ON-SITE SEWAGE DISPOSAL SYSTEM
TANK REPLACEMENT
HOWARD COUNTY HEALTH DEPARTMENT
BUREAU OF ENVIRONMENTAL HEALTH

15507 Bushy Tail Run

SITE INSPECTION SHEET

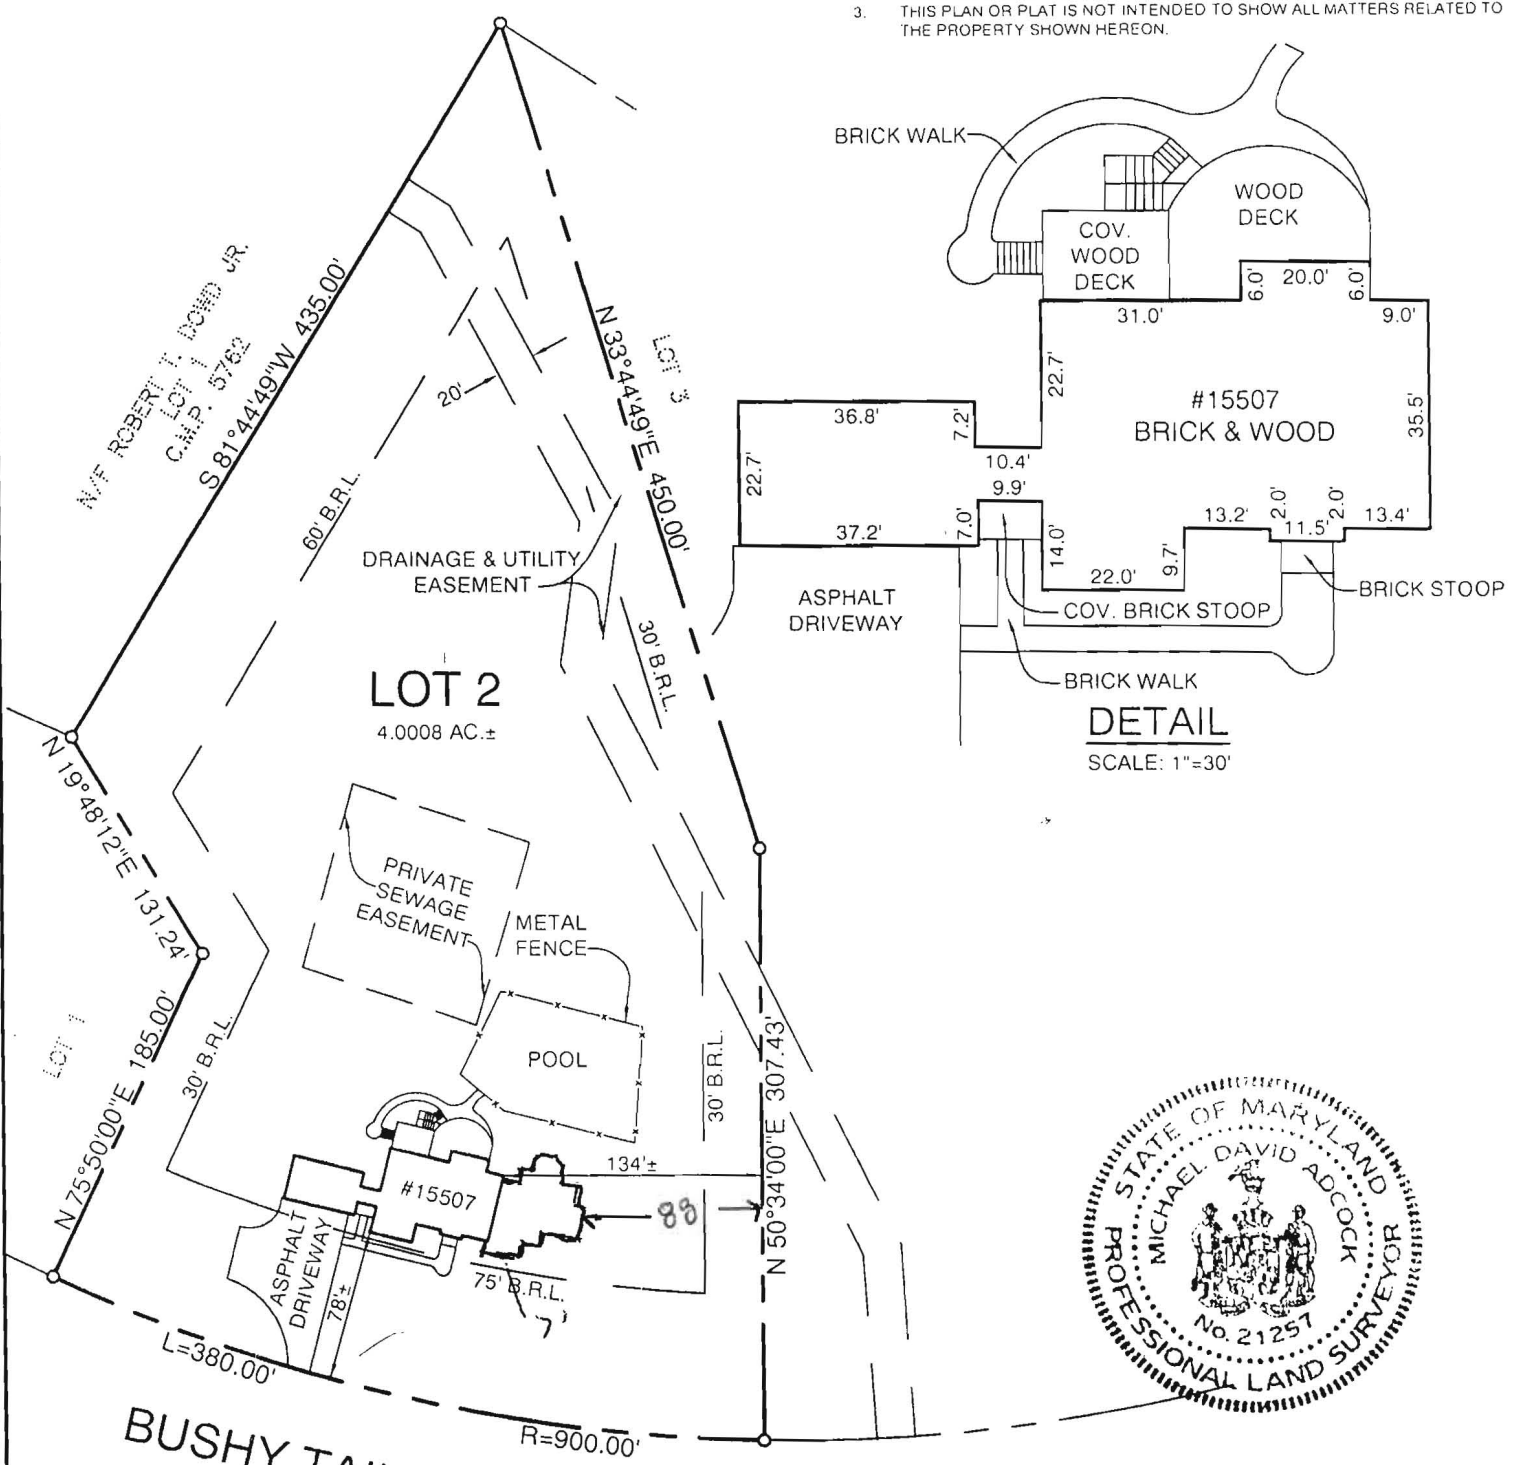
PRE-CONSTRUCTION: 5/18/2012 Install a 1000 gallon tank directly behind the existing tank. Put risers on both tanks. (BB)

INSTALLATION: 5/18/2012 New tank installed. OK to backfill. (BB)

LOCATION DIAGRAM

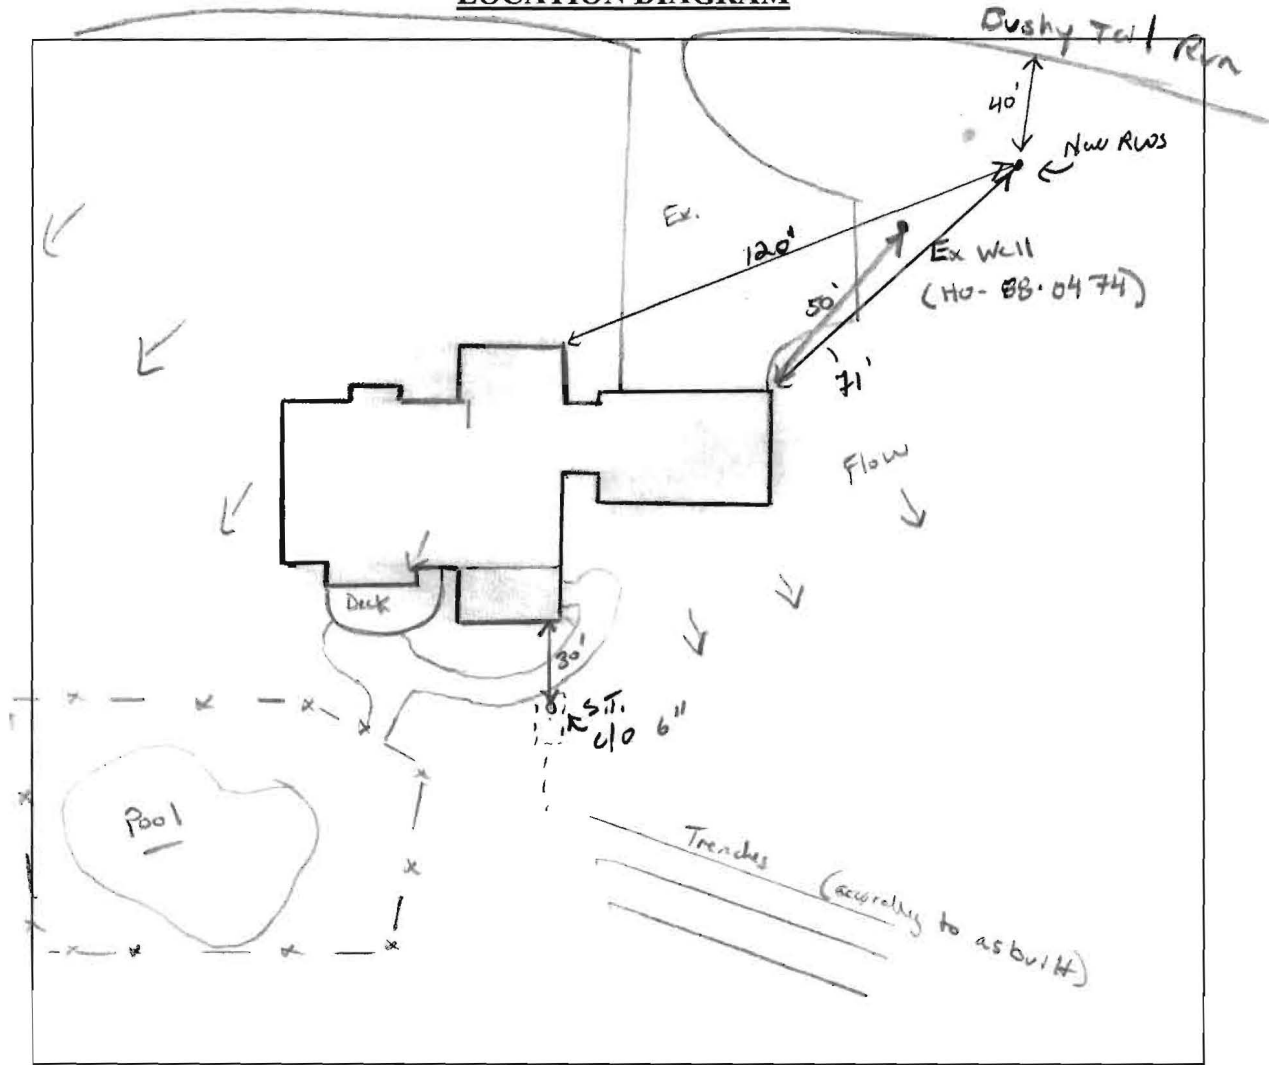
COMMENTS: 5/8/11 site visit confirmed ex well from completion 16.5' deep.
Driller says well has sediment buildup to 50' below grade. Pump set @
50'. New well site closer to road. 4 AC lots. Setbacks OK.
